INVITATION FOR BIDS

CCK-2563.30-4-24 CTC + AAC BP07 Core & Shell Group 1 ADDENDUM #5 July 1, 2024

Addendum #05

Client	University of Kentucky Healthcare	Date	06/28/2024
Project	BP-07 Core and Shell	UK Project#	2563.3
		Champlin Project #	514-6926

DRAWING TITLE LIFE SAFETY - CODE

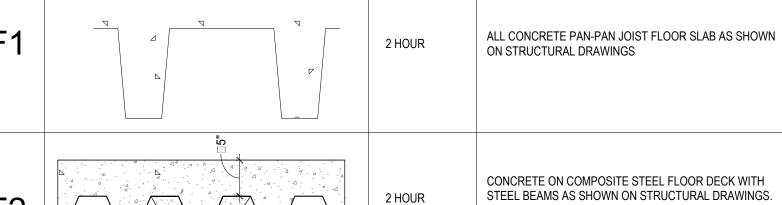
G020 – LIFE SAFETY – CODE SUMMARY

1. Added UL design assemblies.
